# LOTS 0-26, 0-27, AND 0-31-A VOLCANO CLIFFS, UNIT 1 ALBUQUERQUE, NEW MEXICO

## CONSTRUCTION PLANS FOR WATER & SANITARY SEWER IMPROVEMENTS NOVEMBER 2017

## As-Built "Record Drawings"

CITY OF ALBUQUERQUE  
PUBLIC WORKS DEPARTMENT  
ENGINEERING DEVELOPMENT GROUP  
**BEEHIVE HOMES**  
LOTS 0-26, 0-27, AND 0-31-A VOLCANO CLIFFS, UNIT 1  
UTILITY PLAN

UTILITY PLAN  
SCALE: 1"=20'

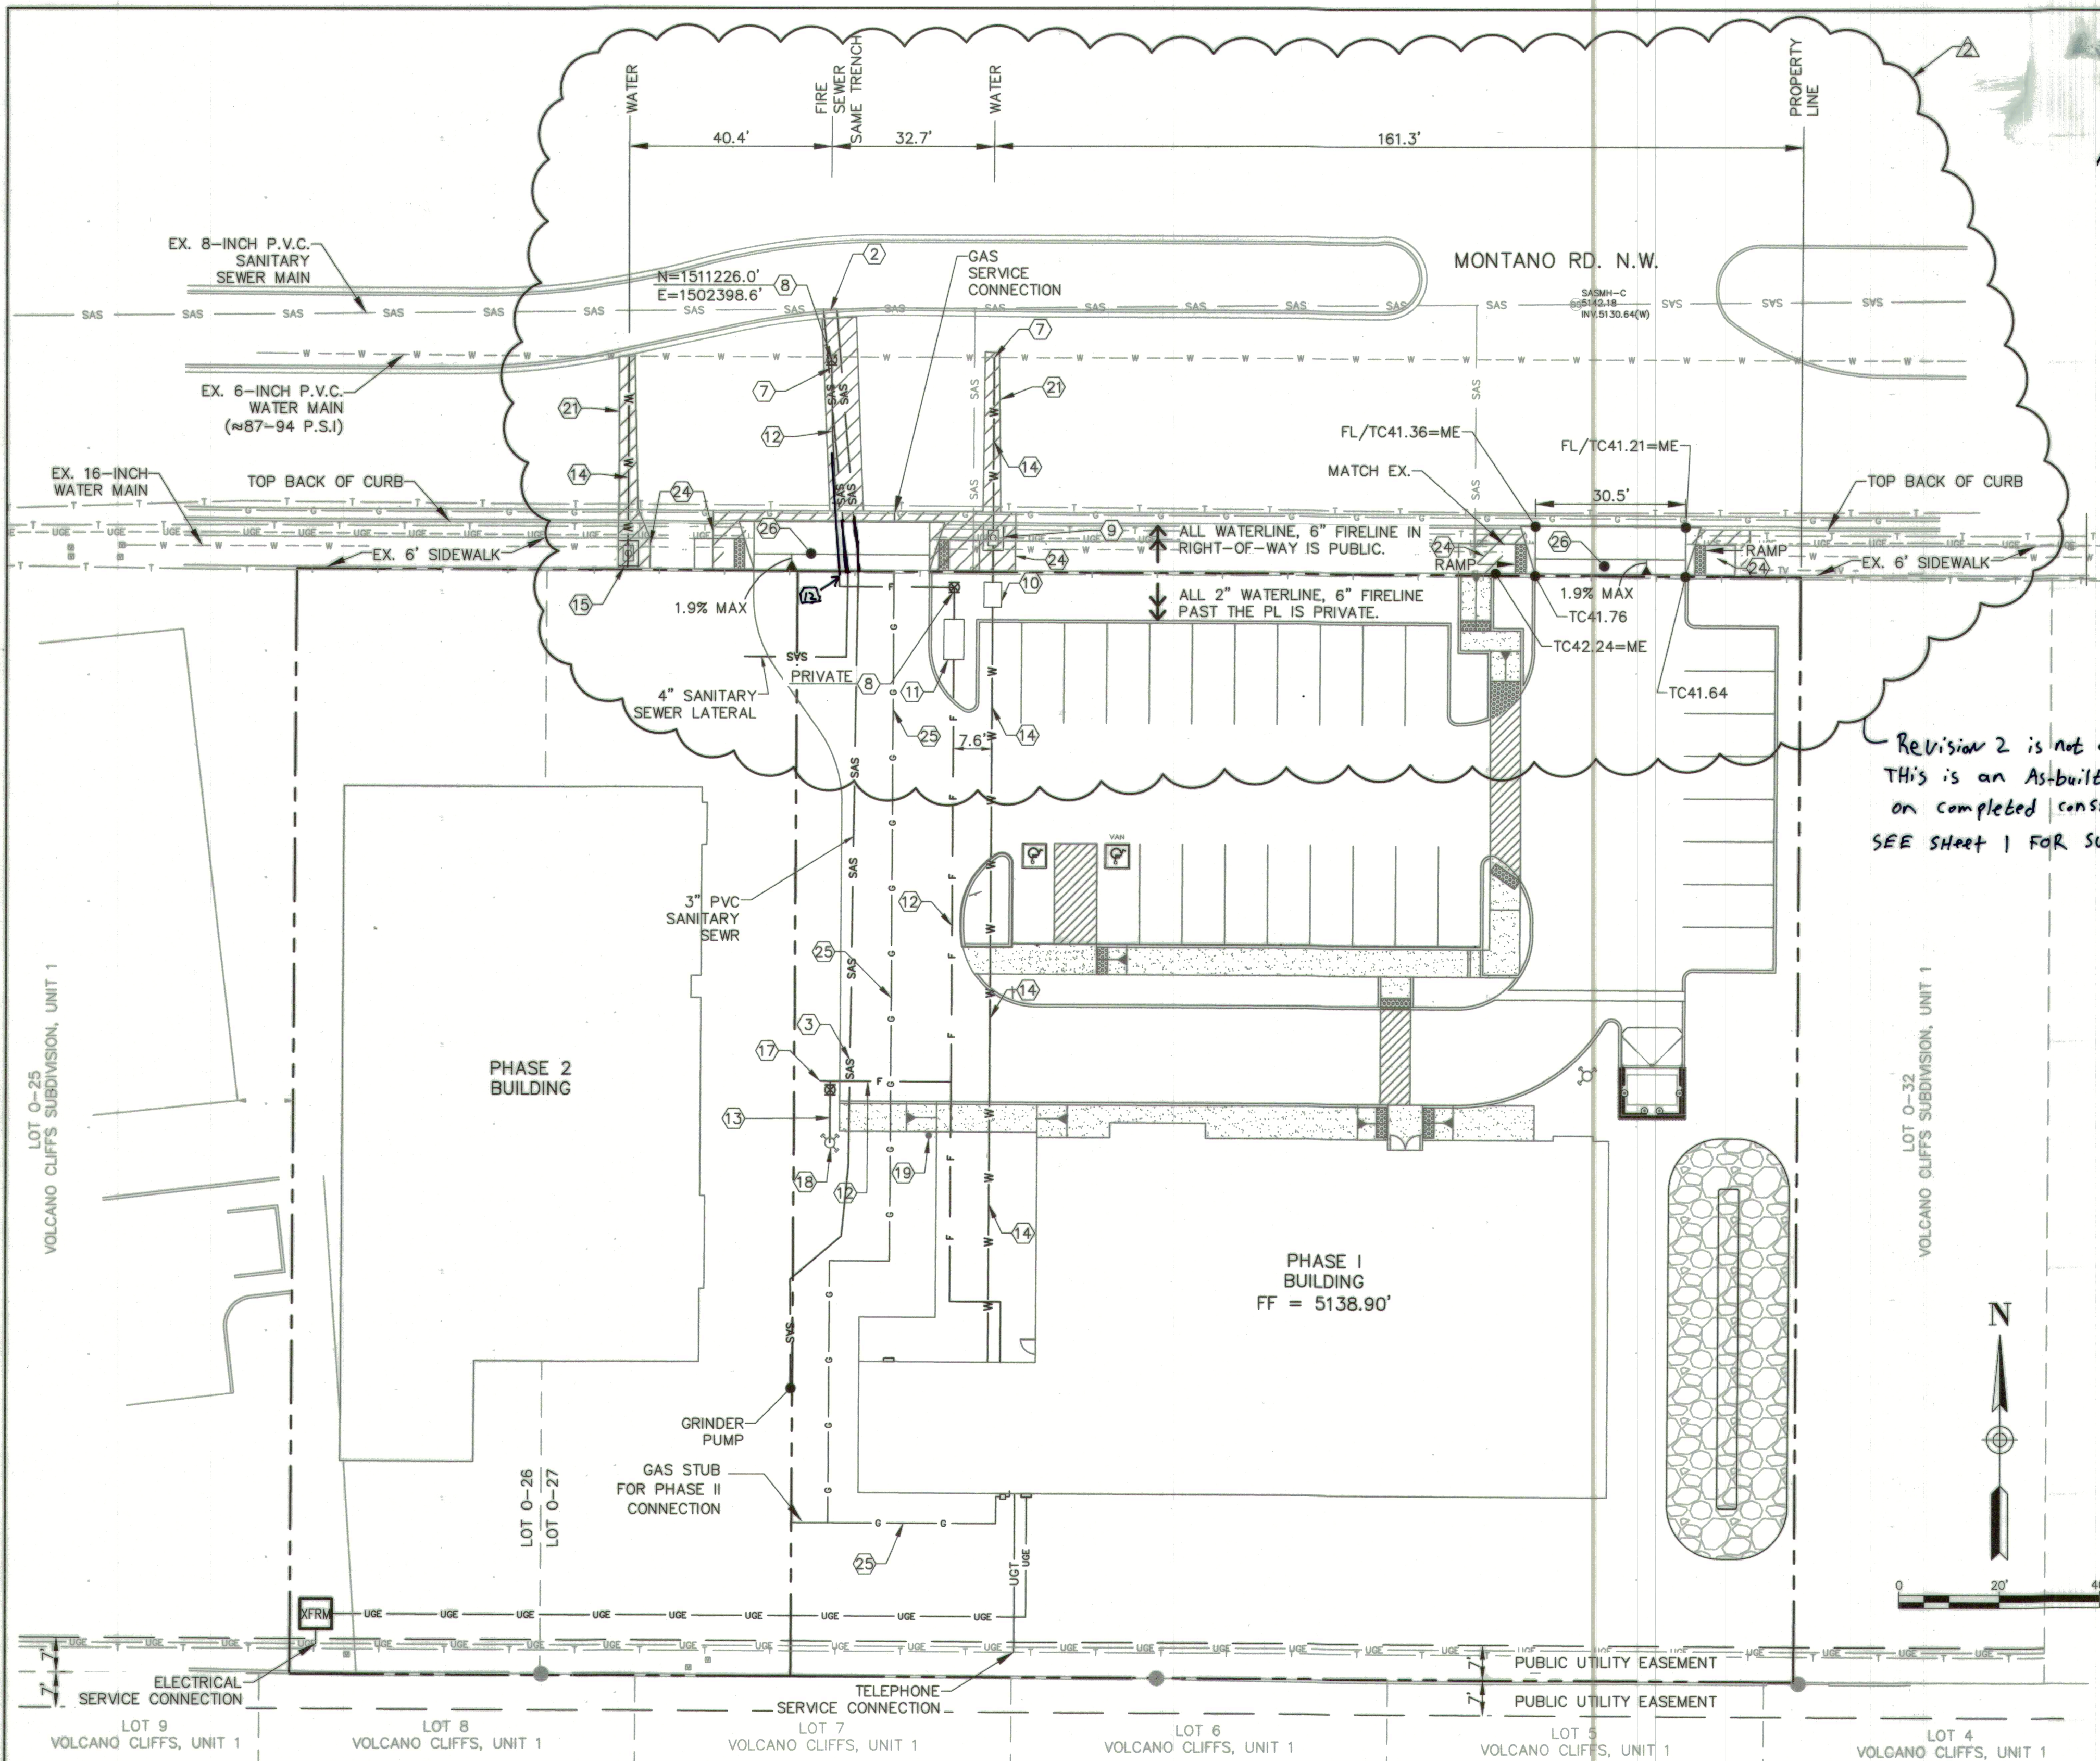
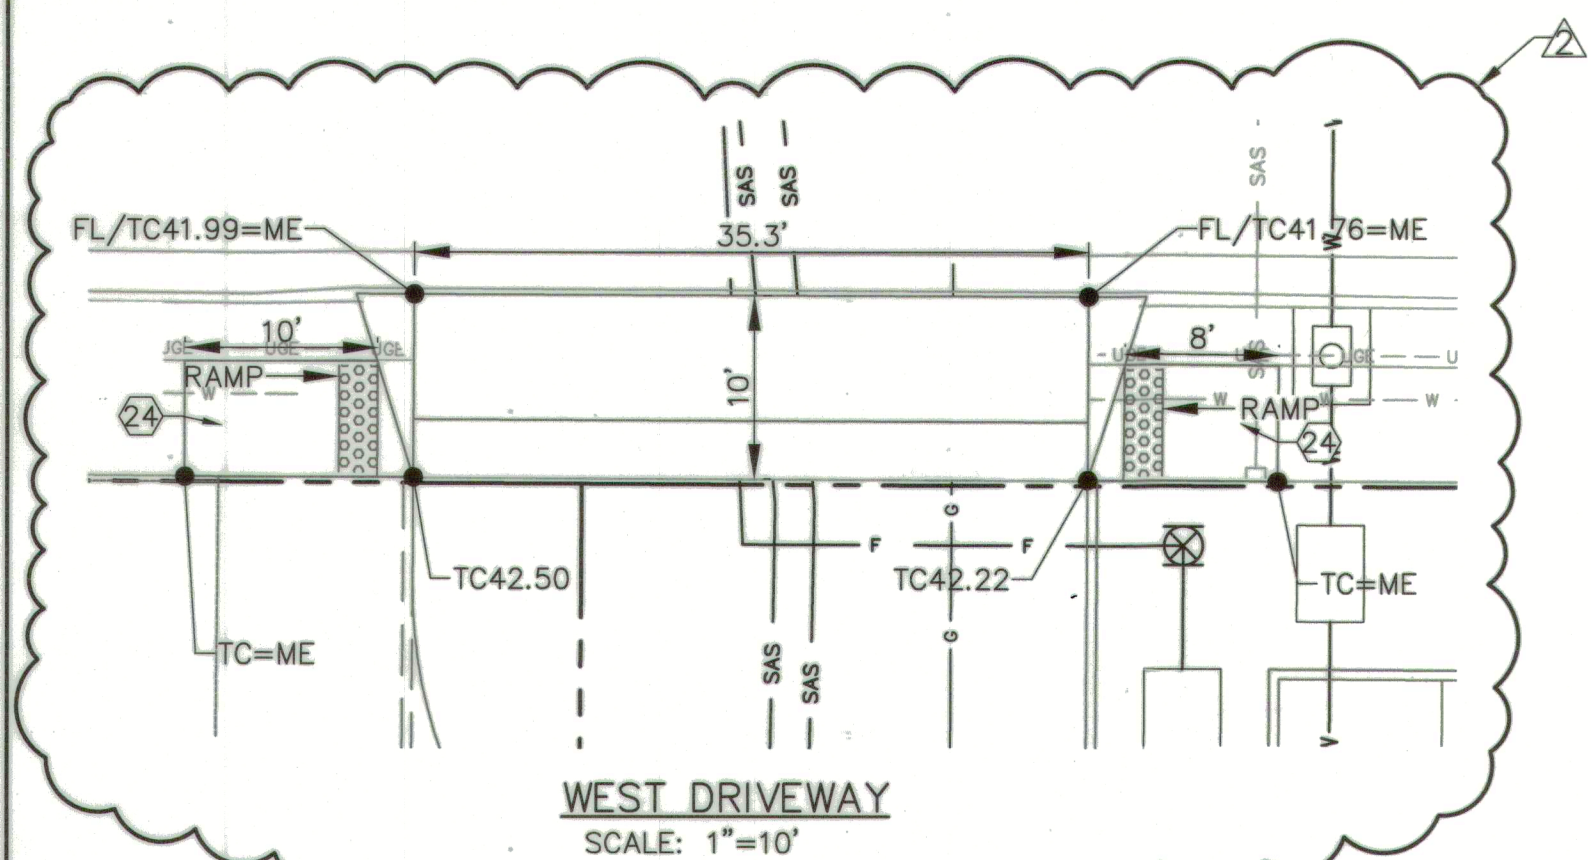
SEE SHEET 3R OF 4.  
THIS SHEET WAS NOT CONSTRUCTED  
PER APPROVED PLAN.  
SHEET 3R OF 4 contains  
ALL REVISION made in FIELD.

UTILITY PLAN  
SCALE: 1"=20'

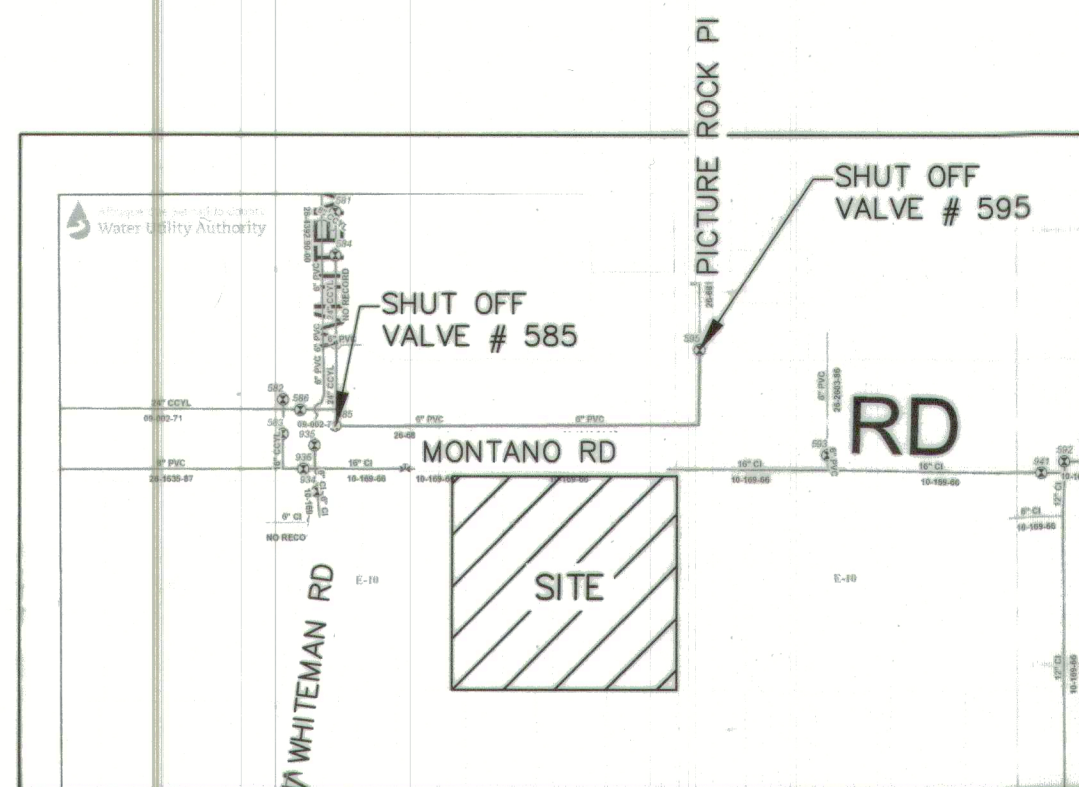
Revision 2 is not a Design Revision.  
This is an As-Built Revision Based  
on completed construction.  
SEE SHEET 1 FOR SURVEYOR'S CERTIFICATION.
